Multi-Sweep 121-C 121-CJ Maintenance

KAY ELECTRIC CO.

MAINTENANCE MANUAL
ISSUE A

ADDENDUM
MULTI-SWEEP 121-CJ
CONTRACT #N600(24-126)65340

FIG. 3-22 MULTI-SWEEP 121-CJ SCHEMATIC, D9278-A

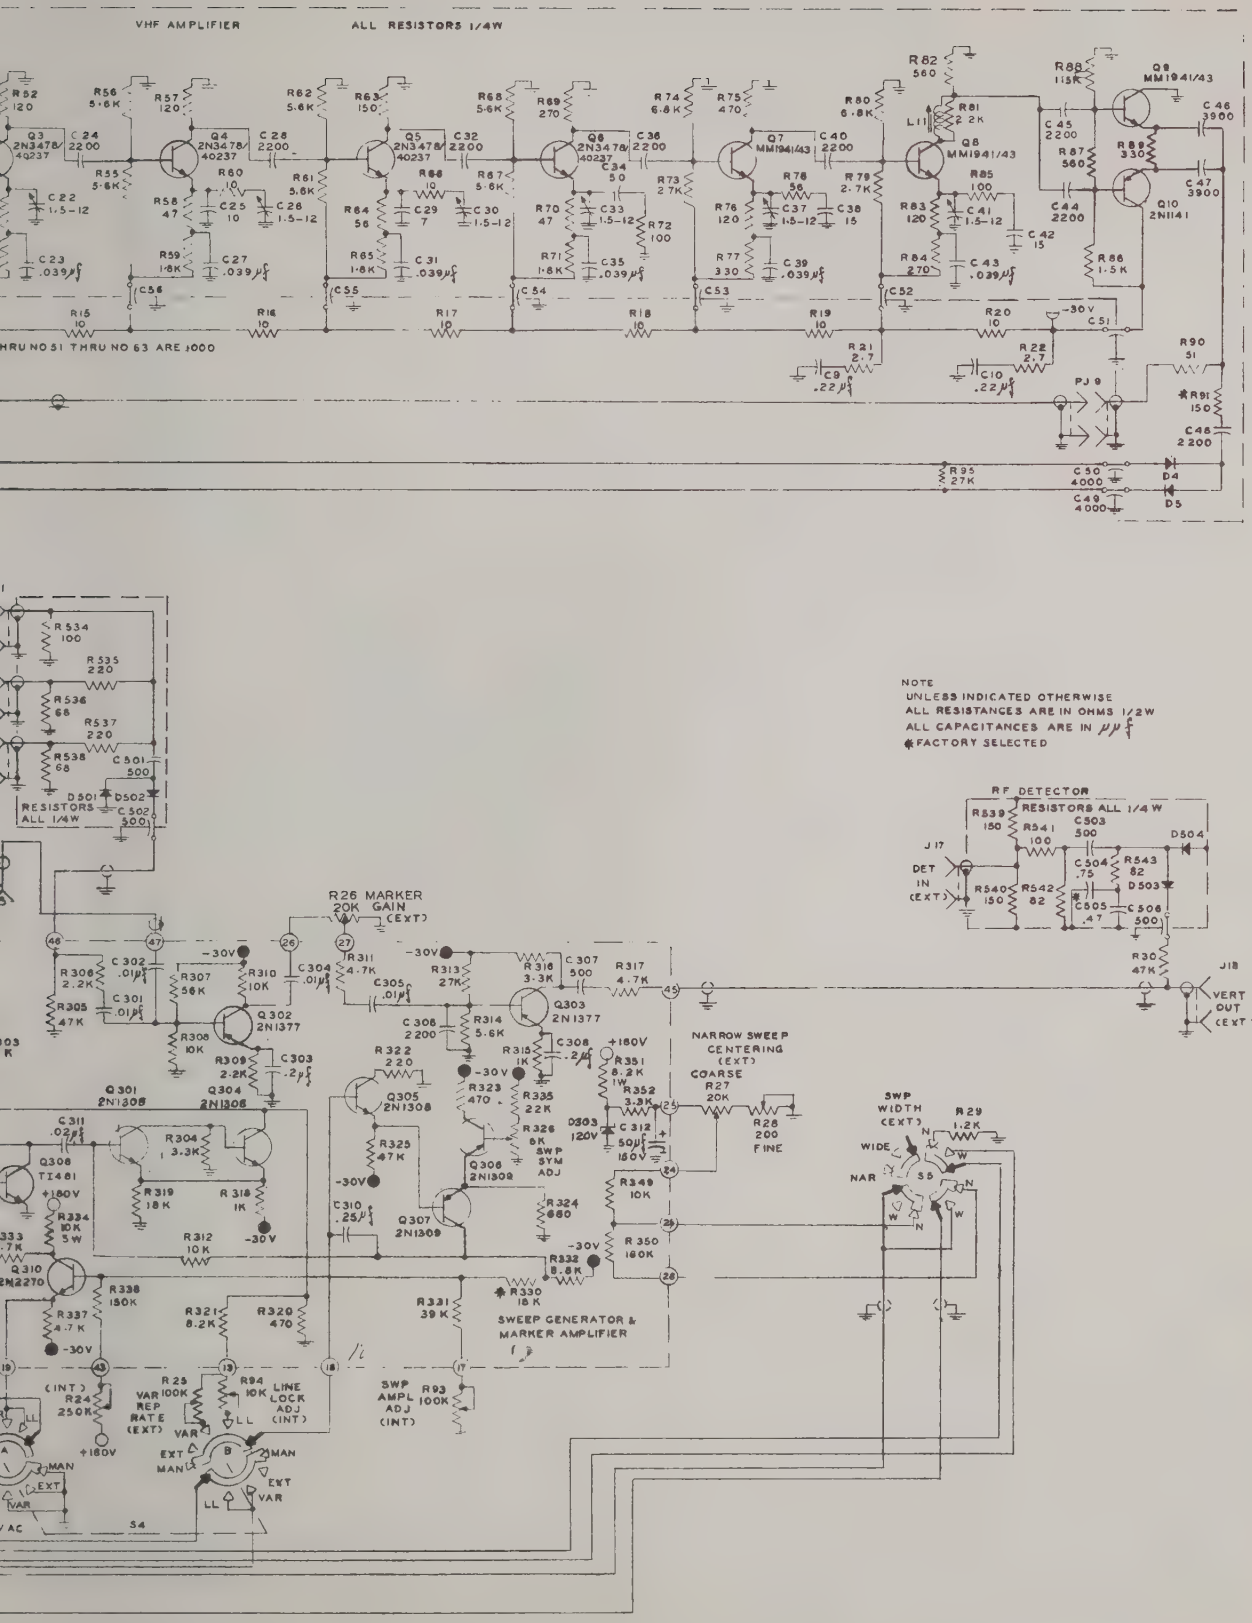
The following modifications have been made to all Multi-Sweep 121CJ units. These changes should be made to the schematic, parts list, and test procedure.

1. Delete all references to RF Output Meter, Harmonic Markers and RF Attenuators.

Change R-328 from 1.8K to 3K.

Change R-328 from 3K to 10K $\frac{1}{2}$ watt, factory selected.

Change Q-301 and Q-304 type 2N1308.

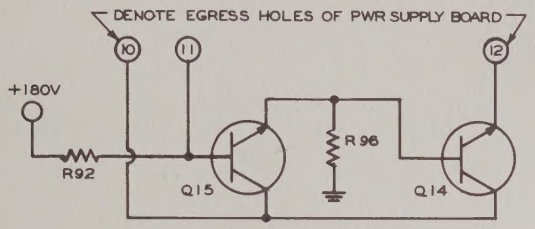
Power supply circuit has been changed as shown:

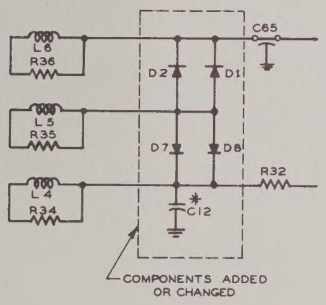
1. Vari-losser circuit has been changed as follows:
   D1 and D2 have been changed to Type 1N126A.
   D7 and D8, (added), are Type 1N126A.
   R33 and C13 have been deleted.
   C12 has been changed to Factory Selected.

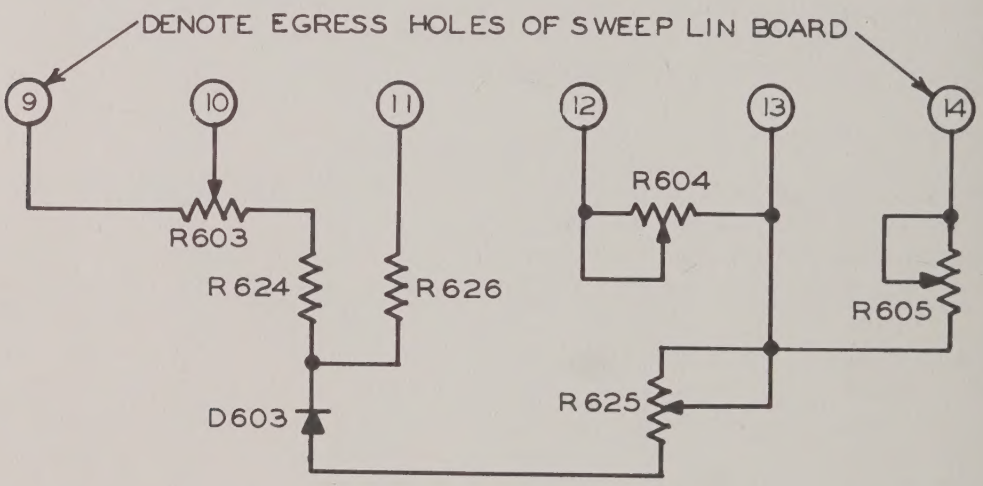
Change:
- R408 to 18K
- R415 to 39K
- R430 to 220Ω
- R603 to 50Ω
- R432 to 75Ω
- R433 to 82Ω
- R436 to 22K
- R435 to 1.2K
- R425 to 22K
- R426 to Factory Selected

Add:
- R624 - 33Ω, ½ W
- R625 - 5K, 2 W Pot, Variable
- R626 - 56Ω, ½ W
- D603 - 1N457A Silicon

The Schematic Diagram should be changed as shown:
